CONSTRUCTION SUMMARY

Lindsay 2017 Developments Inc. / Sugarwood

Lot/Unit: 56 Phase/Building: 2 Model/Floor Plan: Buckhorn Lake (3704) Elev B 4Bed 2.5Bath

SKETCH #1

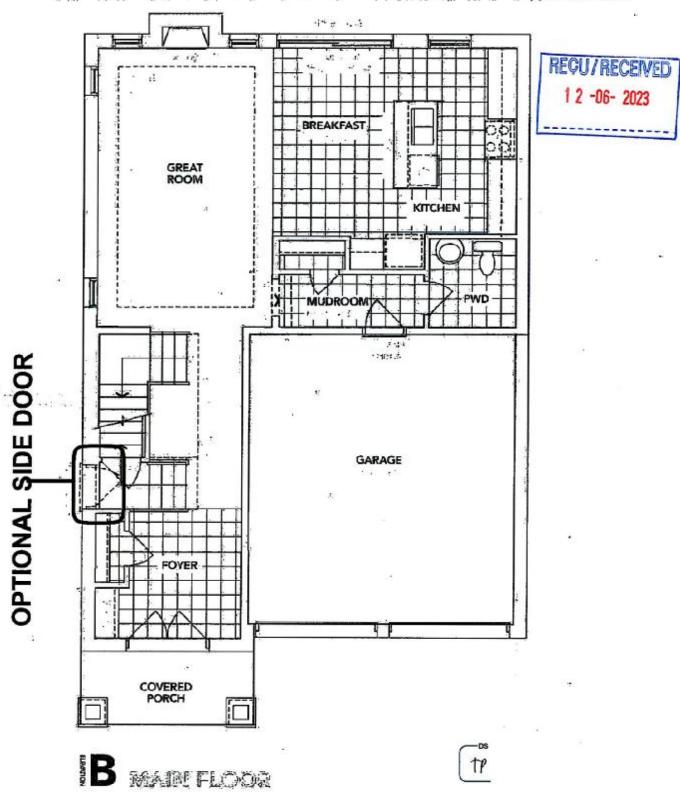
Inv. 6291	1 - TO SUPPLY AND INSTALL THE OPTIONAL SIDE DOOR SEE SKETCH #1	
Line 79267	Note:	
9Jun23 / 9Jun23		
Inv. 6291	2 - TO SUPPLY AND INSTALL UPGRADED BASEMENT WINDOWS (36X24") IN LIEU OF THE STANDARD SEE SKETCH #2	
Line 79269	Note:	
9Jun23 / 9Jun23

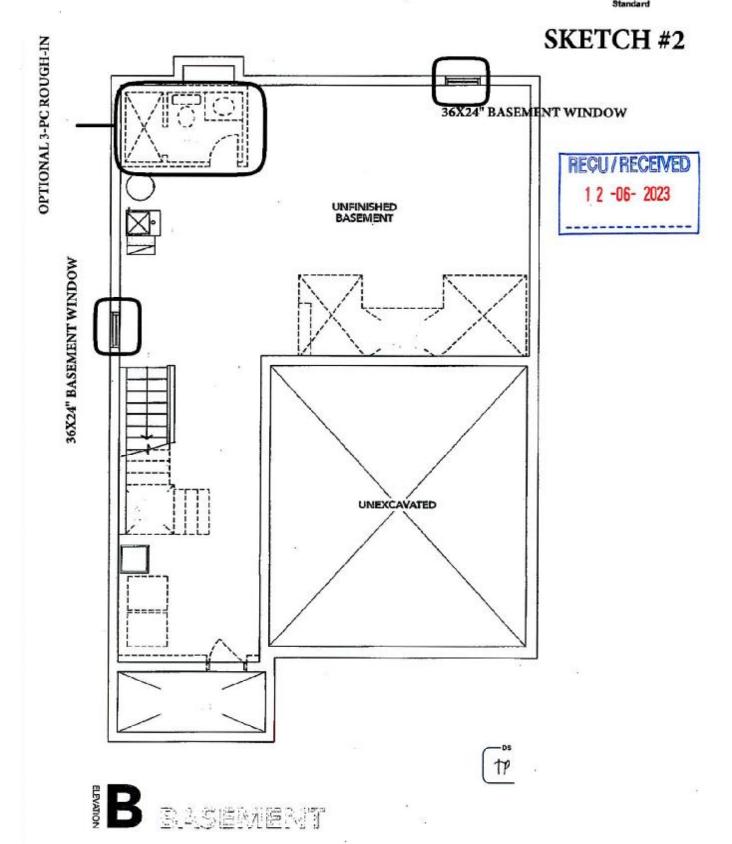
Inv. 6291	1 - TO SUPPLY AND INSTALL THE OPTIONAL 3-PC ROUGH-IN SEE SKETCH #2	
Line 79268	Note:	
9Jun23 / 9Jun23
